31 October 2020

KUDUSBERG WEF ENVIRONMENTAL AUTHORISATION AMENDMENT: SPECIALIST IMPACT STATEMENT

Figure 2. The newly proposed Kudusberg WEF layout overlayed on the original layout (RSA, 2020).

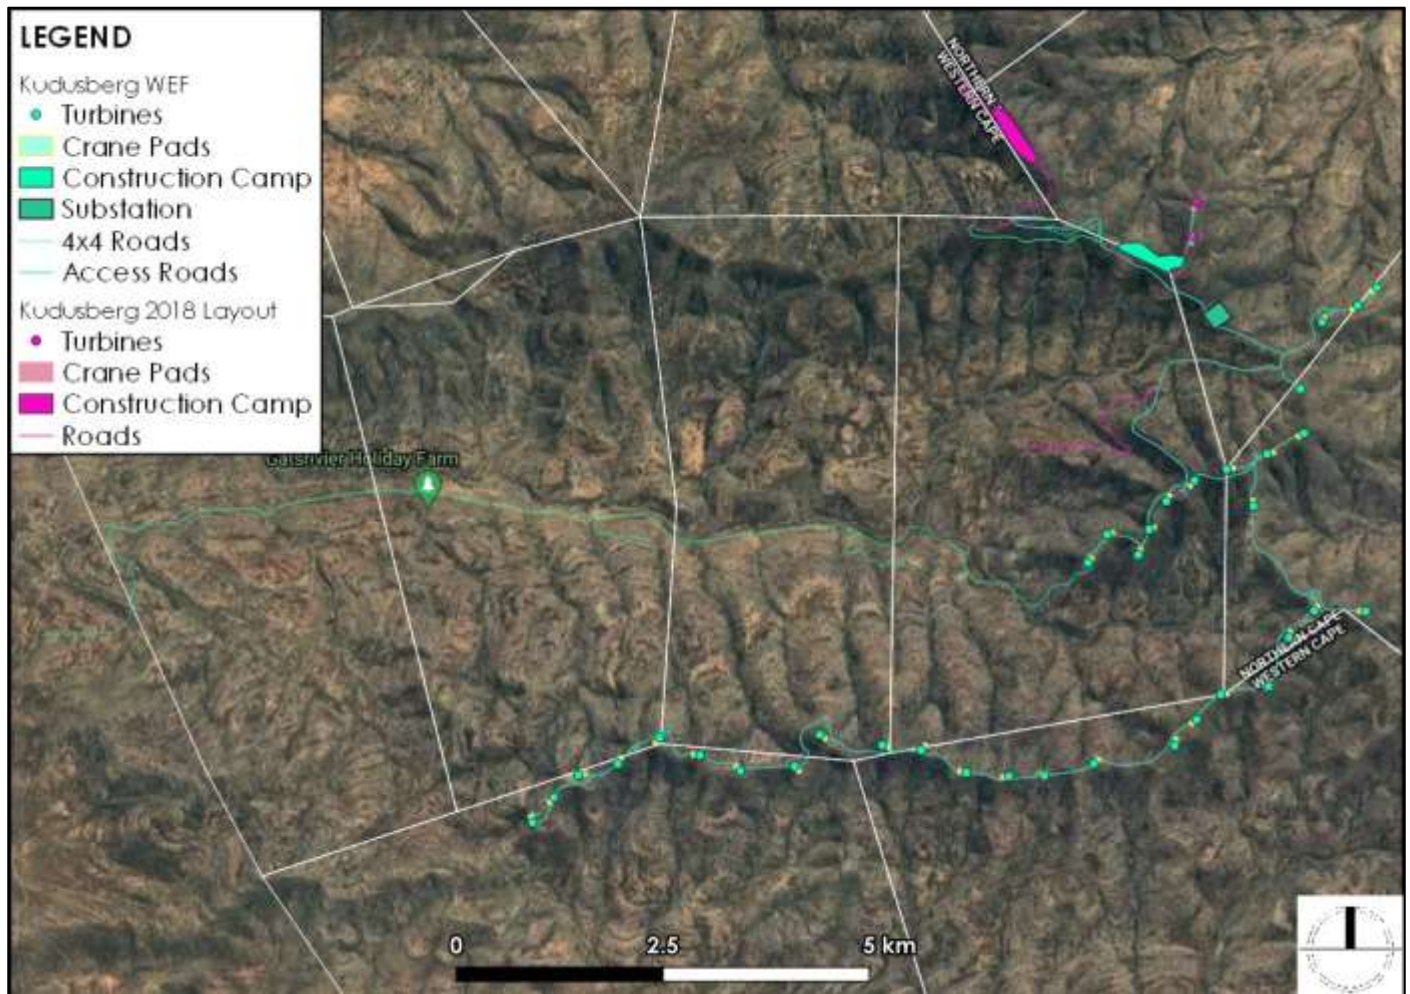
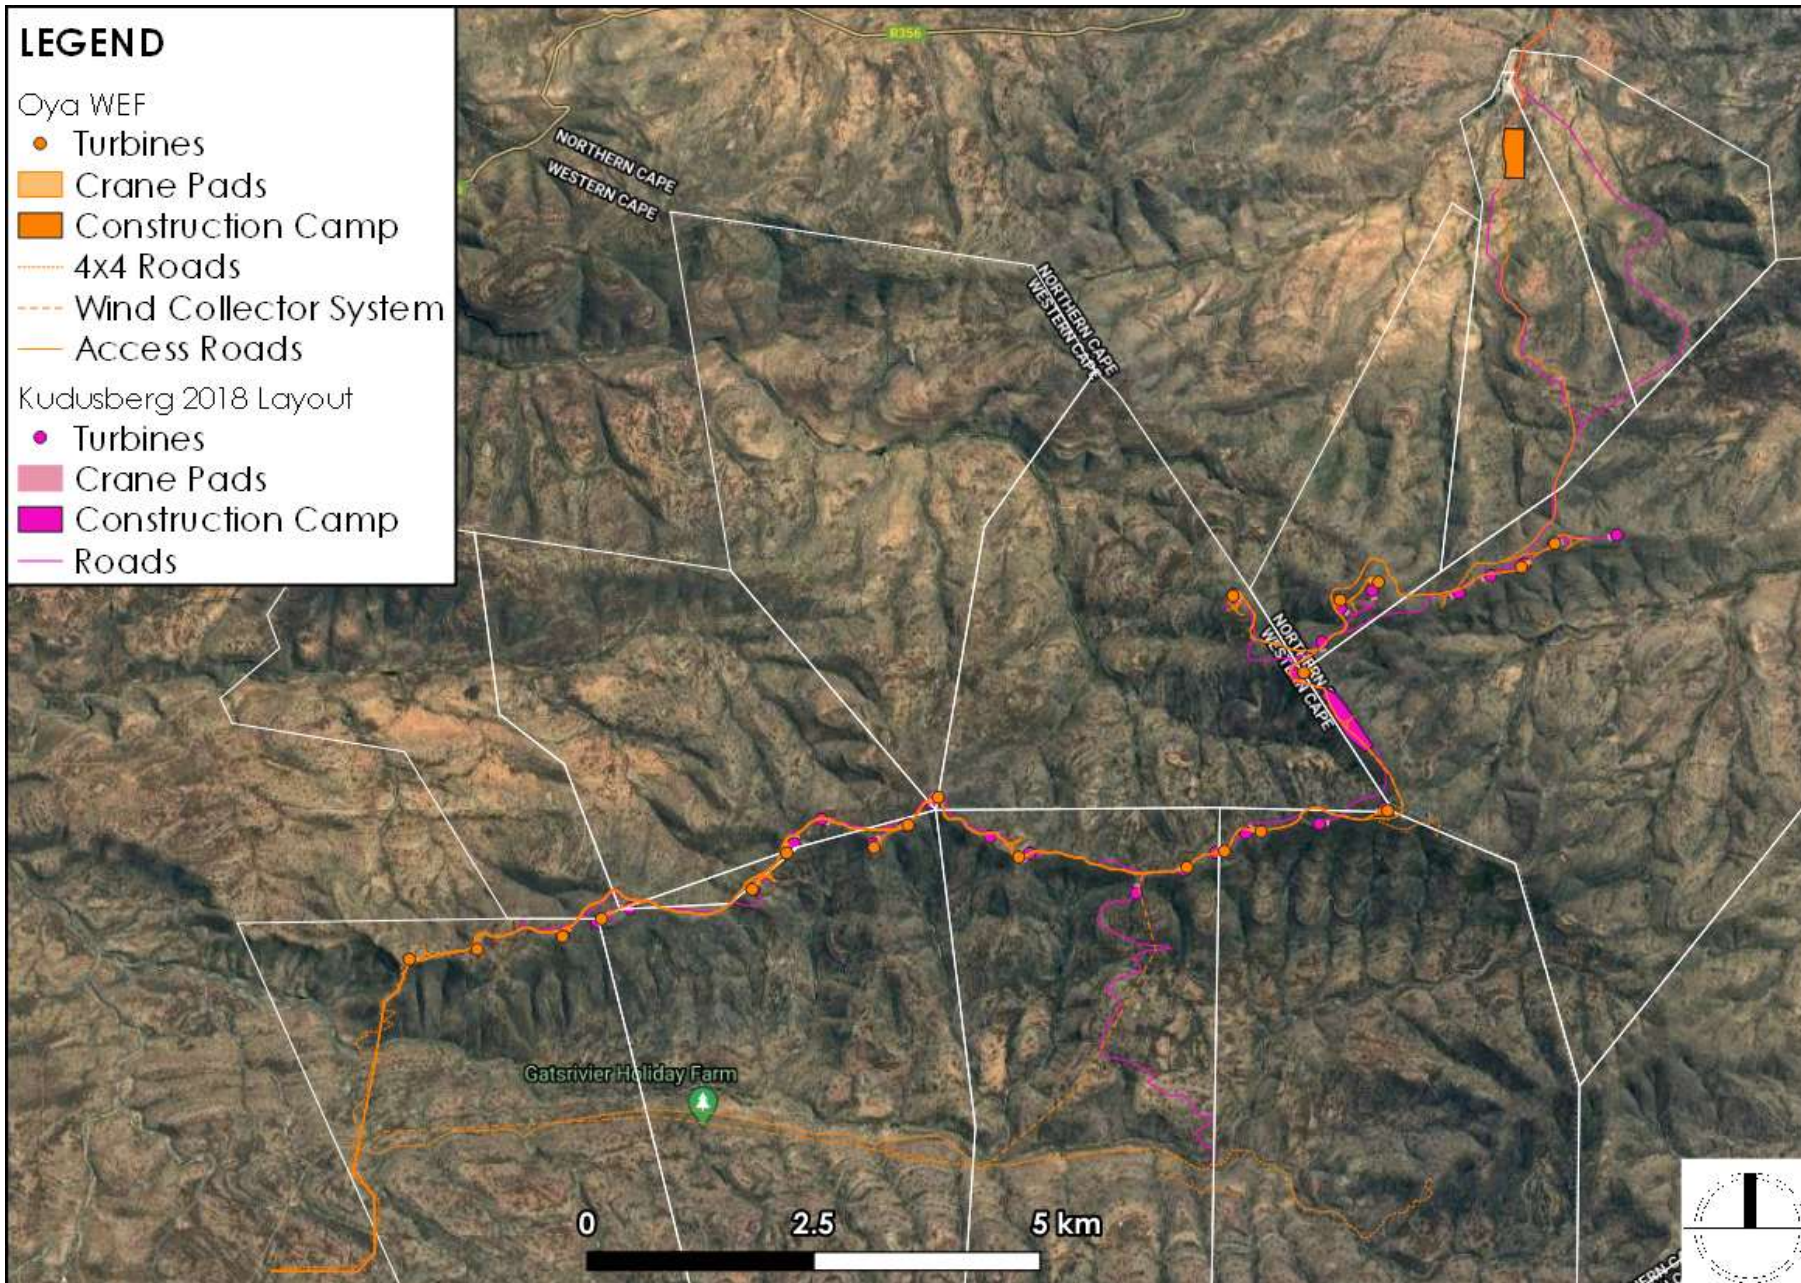
The proposed alignment and layout for this development is largely unchanged from the 2018 proposal (see Figure 2). The total number of turbines proposed for this part of the project area increases from 26 to 36, with all new turbines located along ridge lines. Four (4) new turbines are proposed for the ridge above the Oliviersberg farmstead, but the closest of these is 1.5km away, is situated well outside of the 500m buffer proposed around all farmhouses and is located in an area previously assessed as part of the 2018 BA process.

Most changes in this development area are restricted to the mountain ridges, which formed part of the original assessment and have been shown to be almost entirely devoid of archaeological or built environment features. As such, there are no new, additional or changed impacts to archaeological or built environment heritage resources. As the turbines remain generally in the same location, and are the same height and form as those proposed previously, there is no change in the impacts associated to the cultural landscape or any change to visual impacts of the proposal than previously.

Minimal new internal access roads will be created. Where these are to be built to service turbines, these are along ridges which were previously surveyed and found to be devoid of heritage resources. The route out to the west will be retained as a 4x4 track as it currently is (see Figure 2 and Figure 3). None of the identified structures, ruined structures or kraals along the route to the west will be affected as the road is an established, existing route in and out of the valley, and relevant buffers are not compromised. Where this track deviates from existing routes across the valley floor a

Figure 3. The newly proposed Oya WEF layout overlaid on the original layout (RSA, 2020).

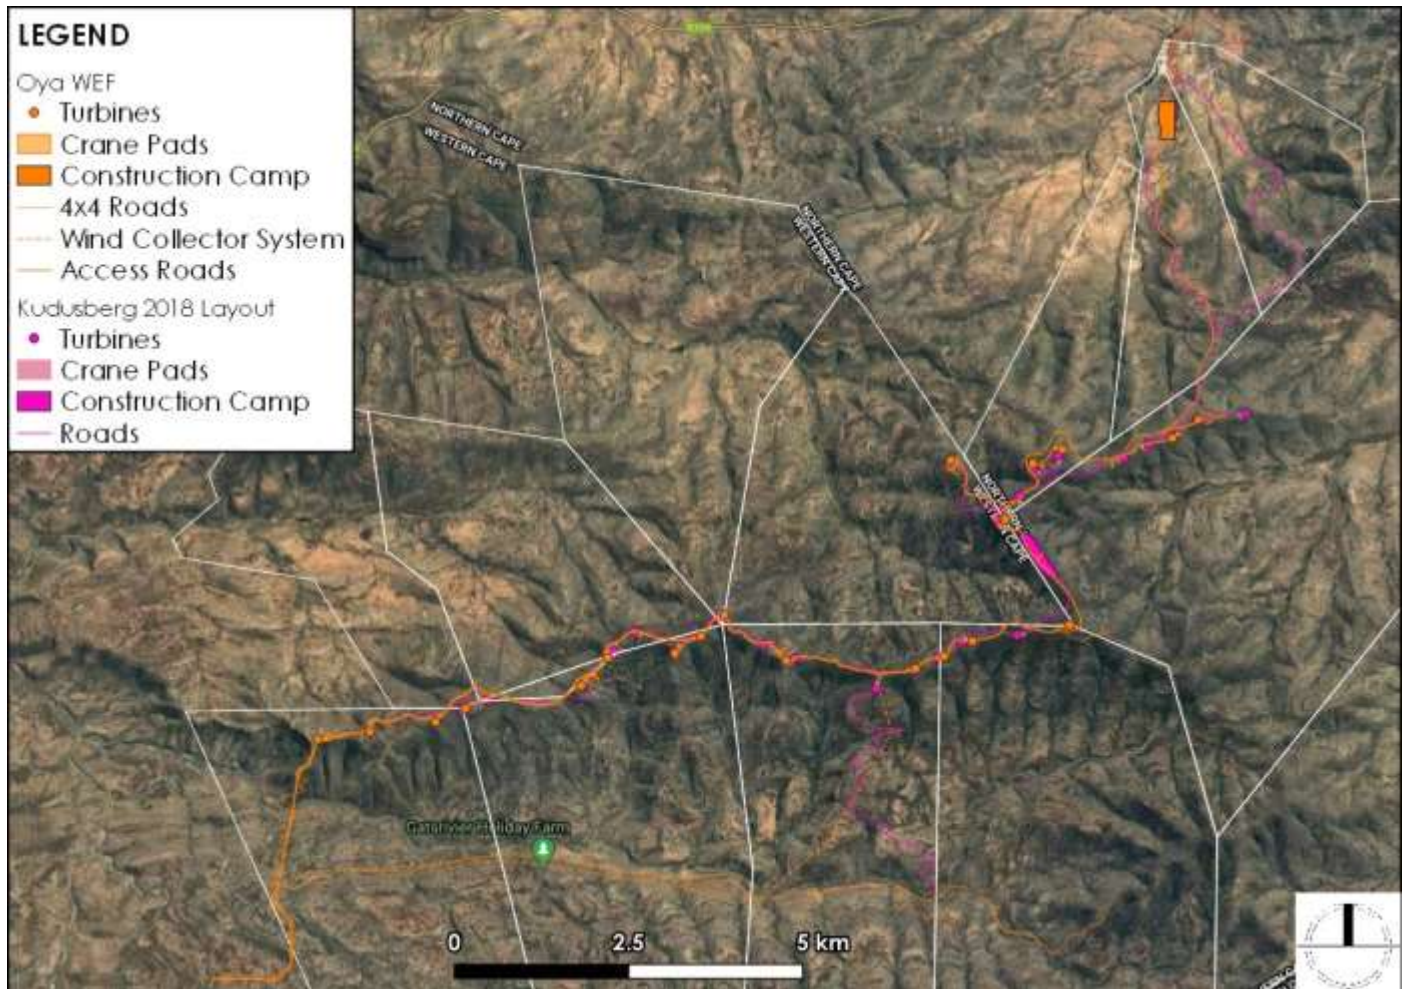
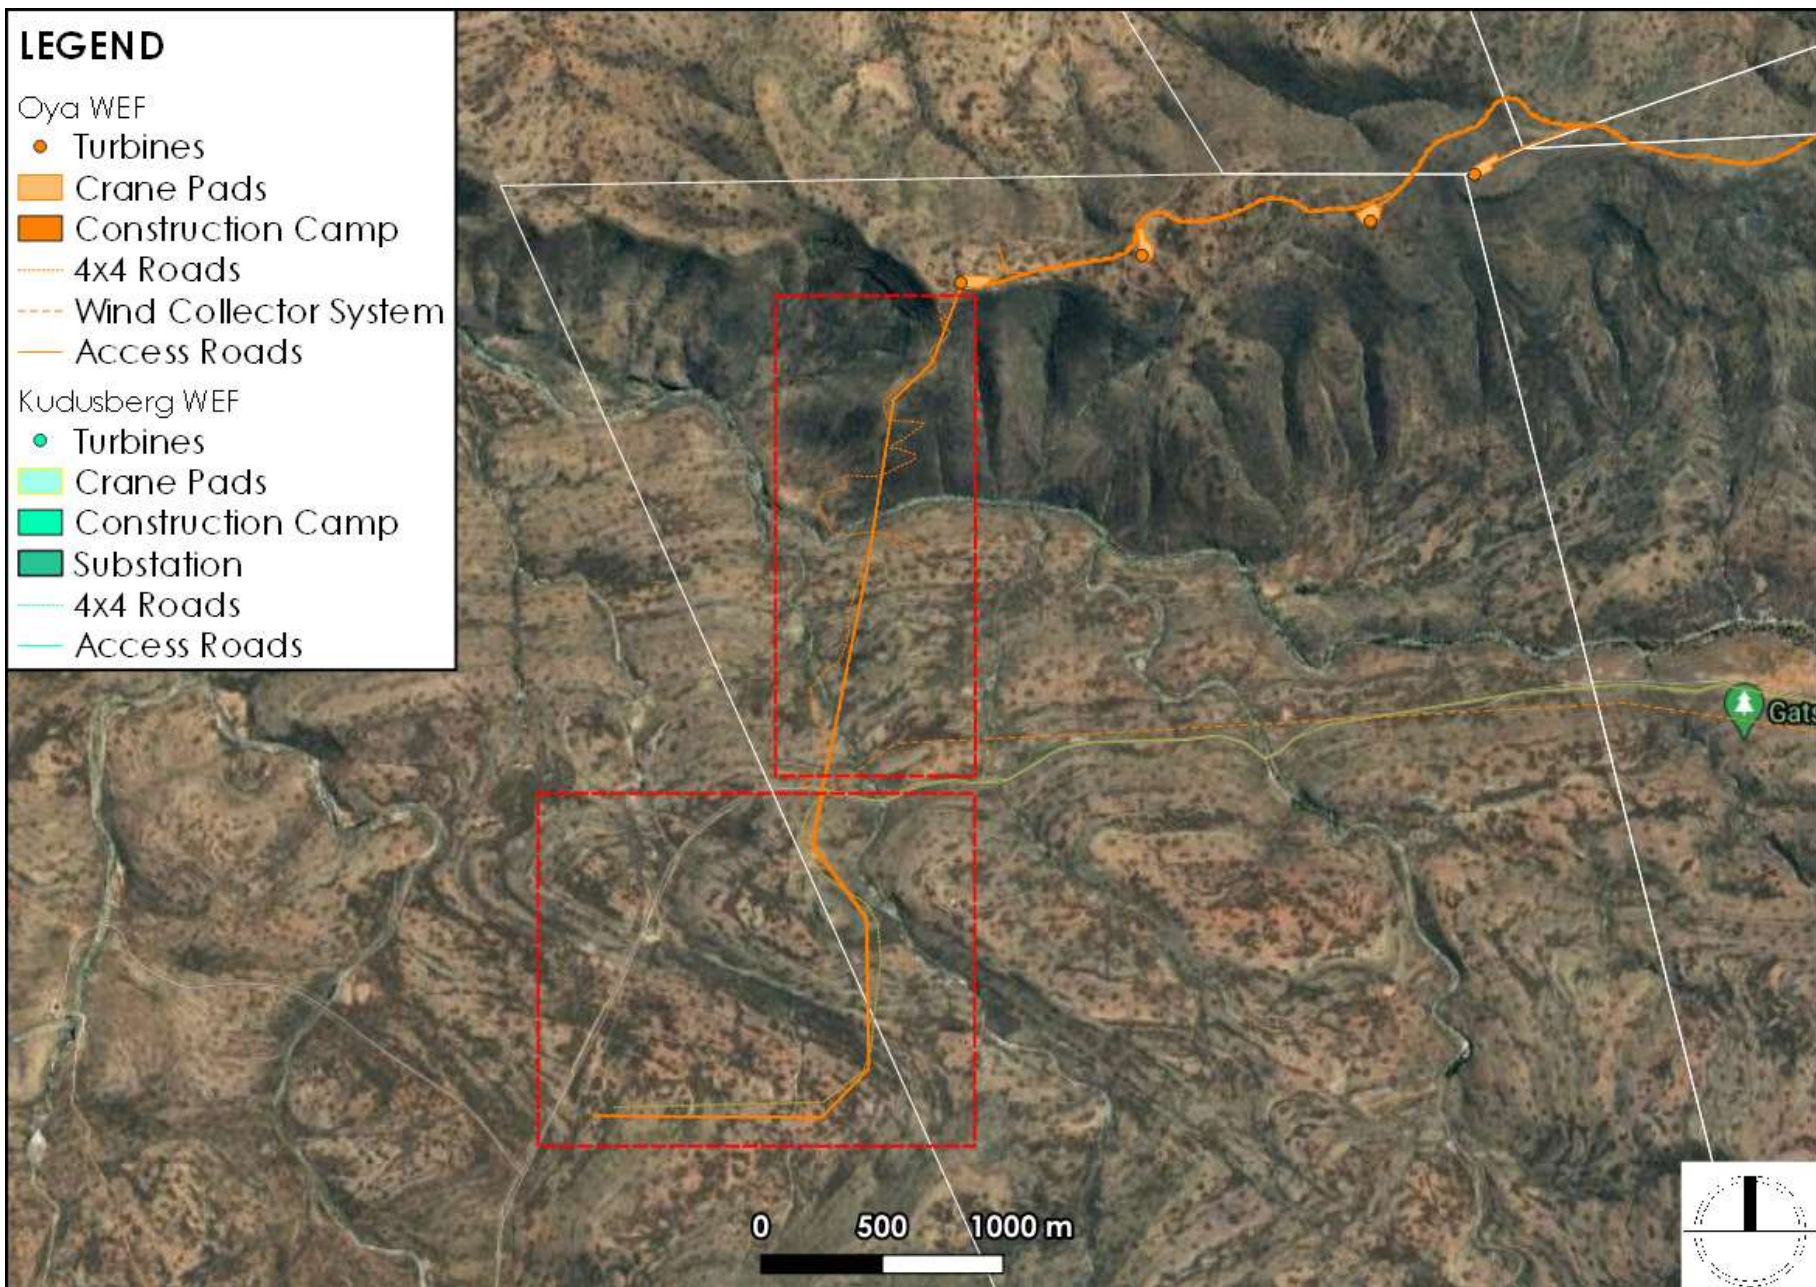
In the case of Oya WEF, the northern portion of the original proposal, there is little substantive change in terms of turbine placement, and the number of turbines proposed for the area remains static (see Figure 3). Most changes are simply repositioning of turbines in the immediate area of those previously proposed. Oya WEF will utilise Construction Camp 2, the recommended and approved construction camp alternative site in terms of the HIA, with no changes in the layout or location of that facility.

Two (2) turbines are moved to the very western end of the previous array, some 1.75km west of the most western turbine previously proposed. These relocated turbines are proposed for a ridge line that has been surveyed and found to be entirely devoid of any kind of heritage resources. Further visual impacts, or impacts to the cultural landscape will be negligible, as the ridge is not close to any scenic or important routes, and the turbines are far removed from the houses at Gats Rivier than any other along that ridge.

Very little change is proposed in terms of the access routes to service the turbines, and, as such, no further or additional impacts are anticipated. The 4x4 route out of the valley to the west is aligned with that proposed for the Kudusberg facility and utilises the alignment of the existing road. A new track will be created up to the western end of the Gatsrivier mountain ridge. This area is also proposed for the alignment of a new Wind Collector System, a 33kV line which could be installed above or below ground. Where the new 4x4 route and the newly installed Wind Collector System, cross the valley floor along new alignments that do not follow existing routes, and where they traverse the lower slopes of the mountains, it is possible that archaeological sites and features might be present. As such, a walkdown should be undertaken by a suitably experienced archaeologist (see Figure 4). It should however be noted that a detailed walkdown of the proposed layout is being undertaken by a suitably experienced archaeologist accordingly, and the findings are presented in a separate standalone walkdown report which does not form part of this letter. In addition, a Heritage Management Plan (HMP) is being compiled by this archaeologist and will form part of the EMPr which is to be submitted to the DEFF for approval.
